Summary of Critique of
"Infant Mortality and Nuclear Power
Generation" -- Dr. Ernest Sternglass
by
Staff of the Atomic Energy Commission

Critique of "Infant Mortality and Nuclear Power Generation" --
Dr. Ernest Sternglass

by
Staff of the Atomic Energy Commission

Fig 1

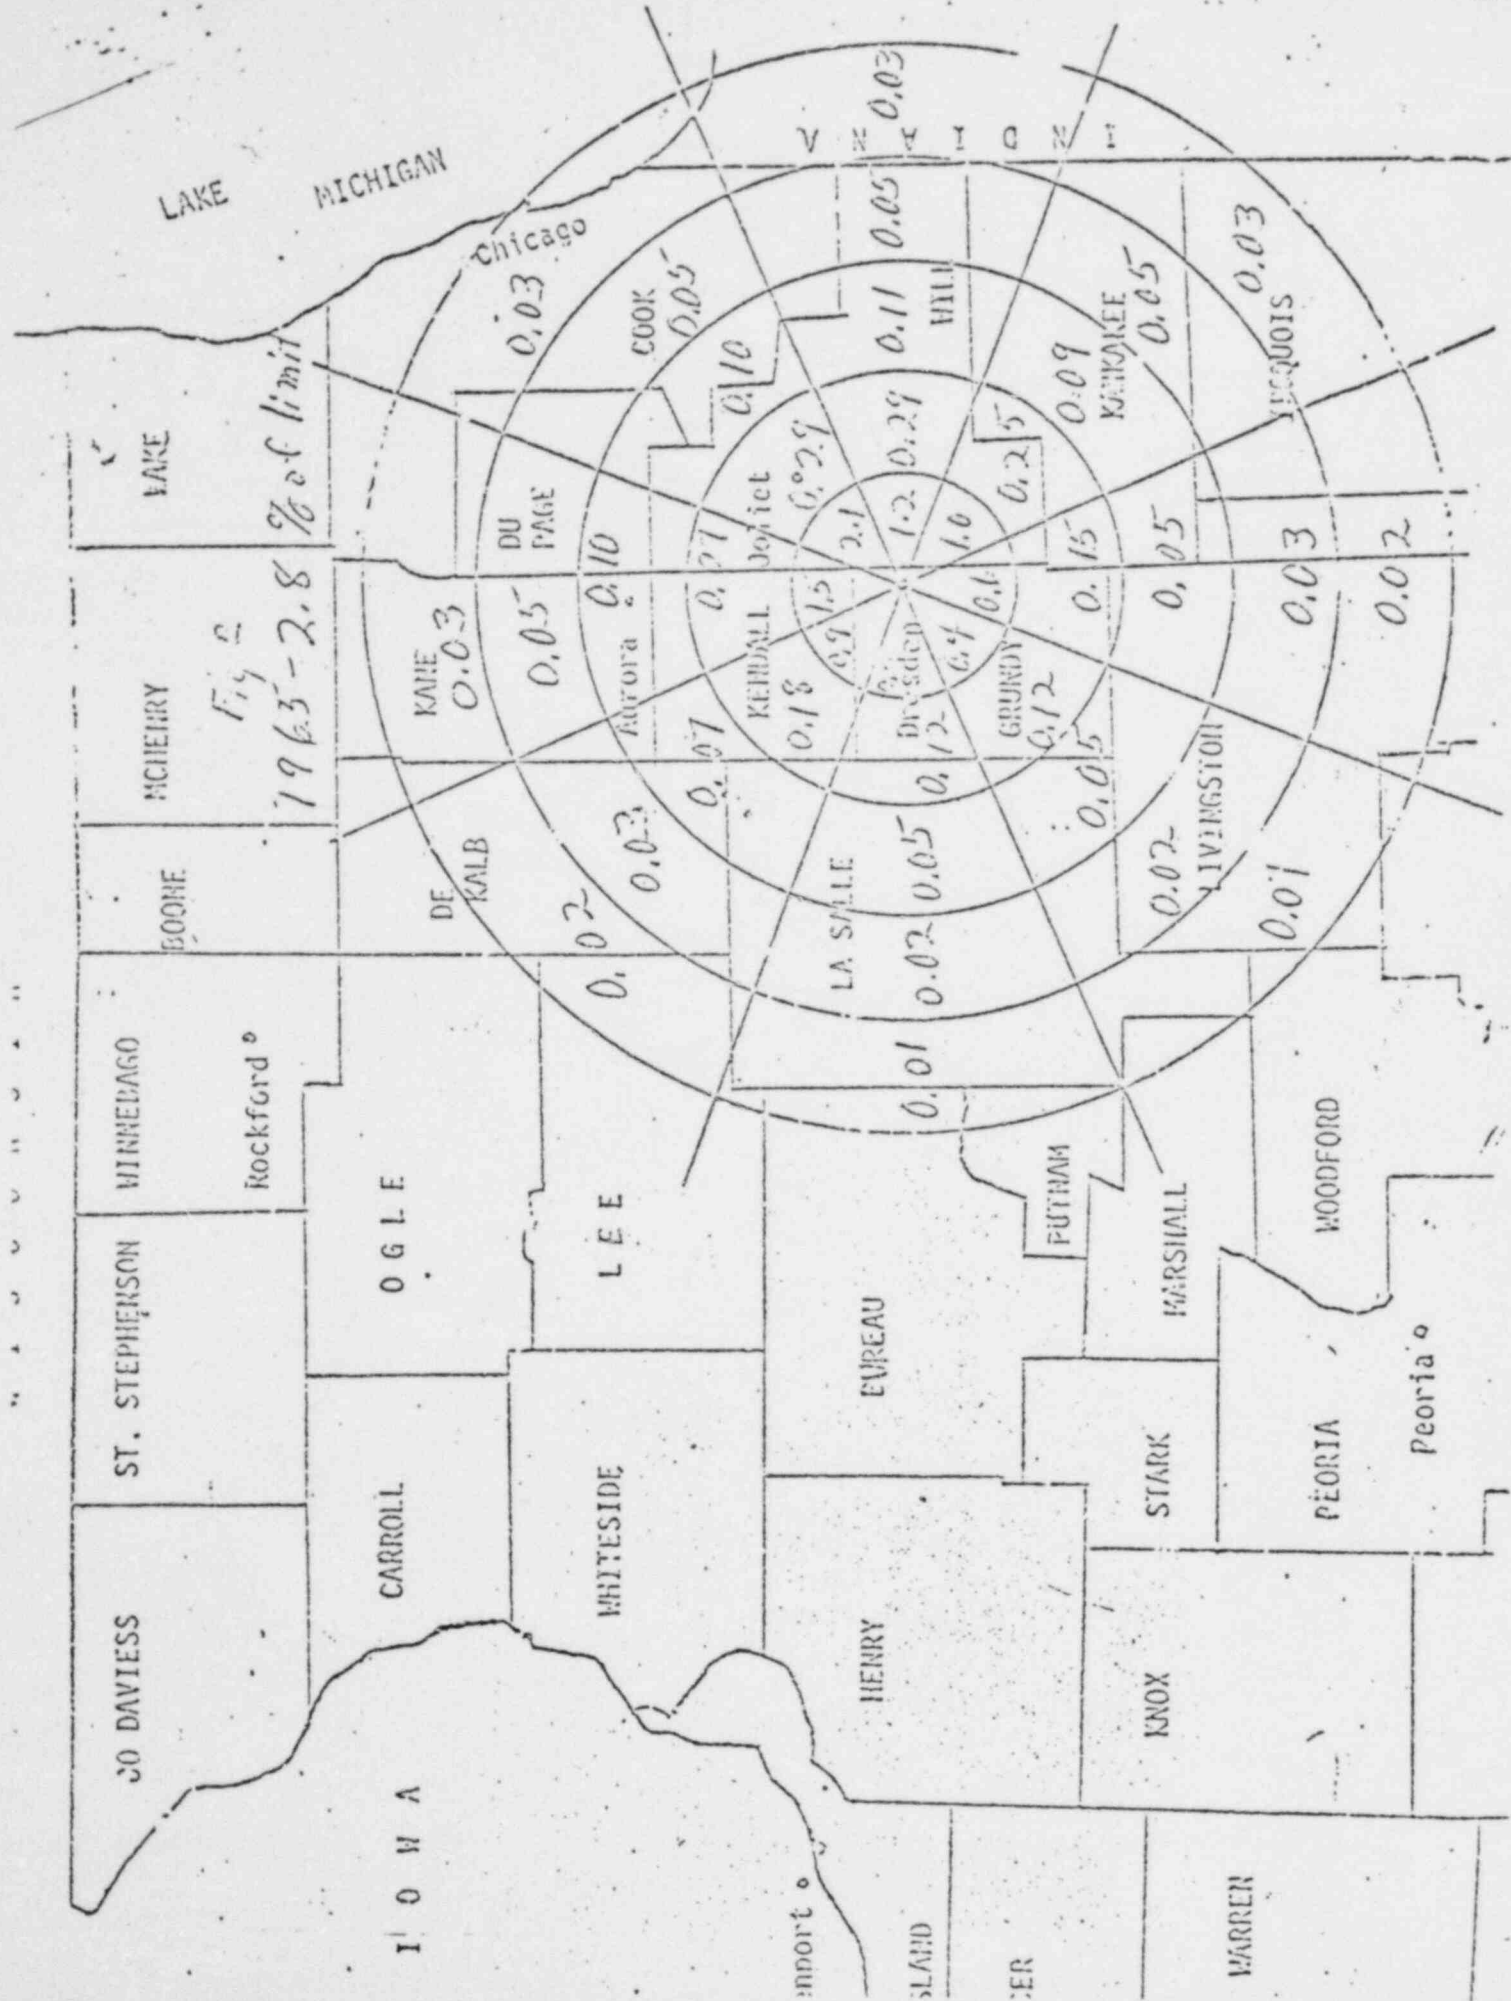
Dr. Stern-glass contends that infant mortality rates in the State of Illinois rise and fall in parallel with the quantity of radioactive effluents from the Dresden plant. The basis for his contention is summarized in his Figure 1 and reproduced here, except that data for the year 1969 have been added by us. Figure 1 also indicates the steady decline in the infant mortality rates for the State of New York from 1959-1968, which Dr. Stern-glass compares with the rates for the State of Illinois.

If excess infant mortality rates result primarily from irradiation in utero, as implied by Dr. Stern-glass, then the increase would be expected to be found in recorded data the year following birth. Thus, excess death data should lag the effluent data by about a year. Figure 1 does

not show any consistent trend between the two variables of infant mortality rates and effluent data, i.e., some time periods indicate a parallelism while other periods do not.

The first year that substantial quantities of radioactive effluents occurred was in 1962 yet the infant mortality death rate in that year (as well as 1963) was lower in Illinois than New York State. Dr. Sternglass implies that fallout from nuclear weapons tests caused higher than expected rate in New York State in 1962 but that hypothesis has been completely discredited. (3) (4) (5)
